ATTACHMENT TO LICENSE AMENDMENT NO. 6

FACILITY OPERATING LICENSE NO. DPR-73

DOCKET NO. 50-320

THREE MILE ISLAND NUCLEAR STATION, UNIT 2

Figure 2.1-1 Reactor Core Safety Limit

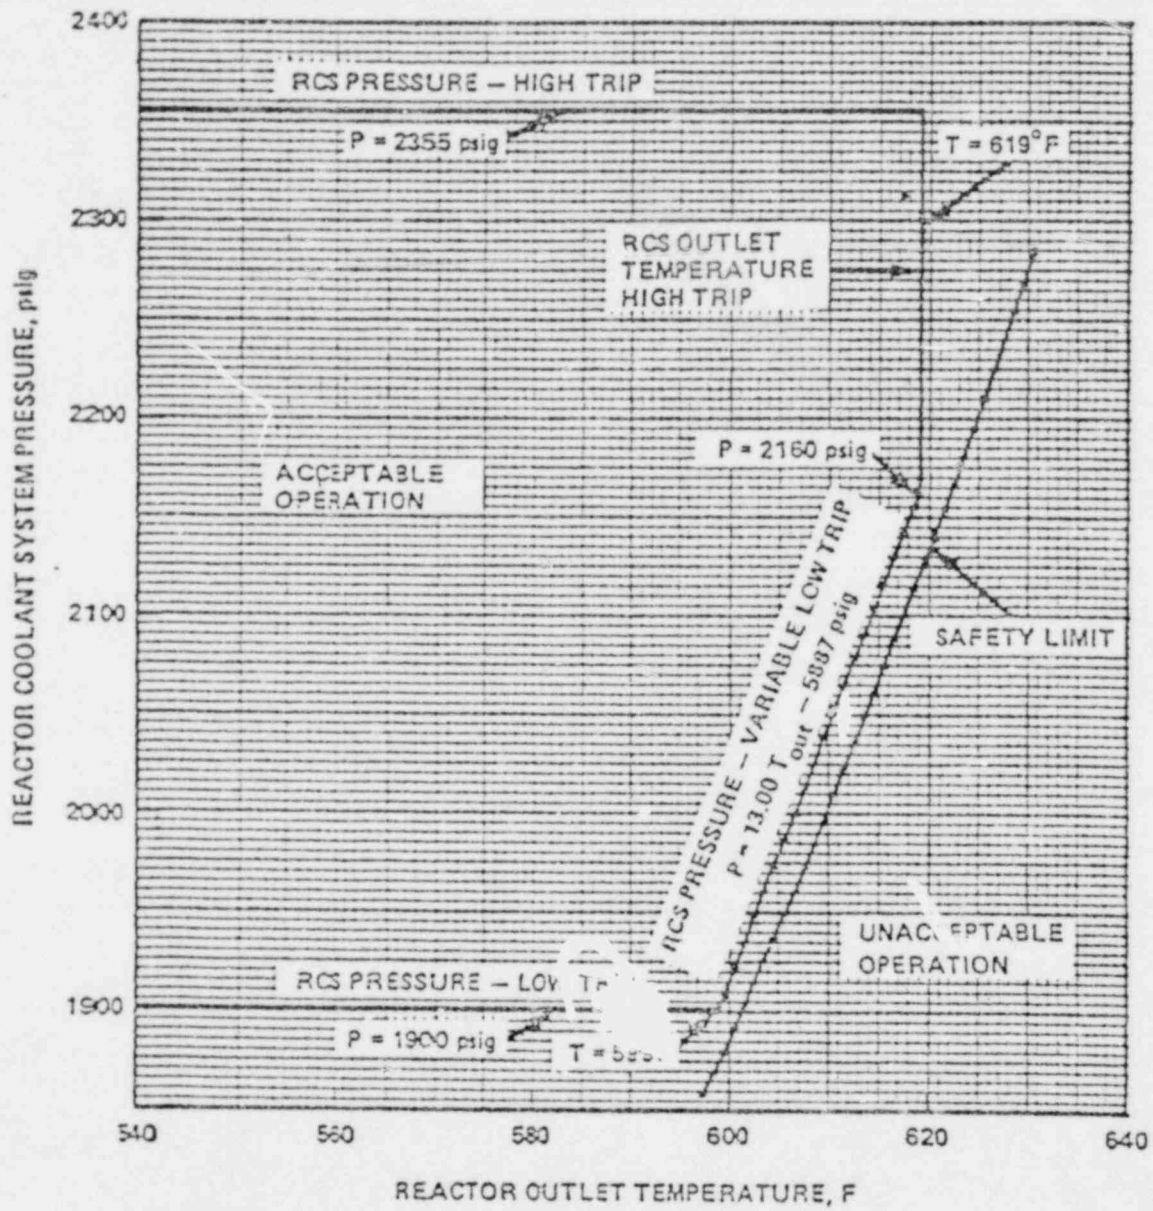
The rod bow penalty has been revised to correctly reflect the NRC rod bow model. The original Technical Specification was prepared using the B&W rod bow model and during investigation into the removal of the ORAs was discovered and is corrected herein.

The original calculations for a rod bowing penalty had been performed with a B&W rod bow model that we found unacceptable. We have verified that the revised rod bow model as presented in the change request conforms with the NRC-approved rod bow equation for B&W plants. Therefore, we find this change acceptable.
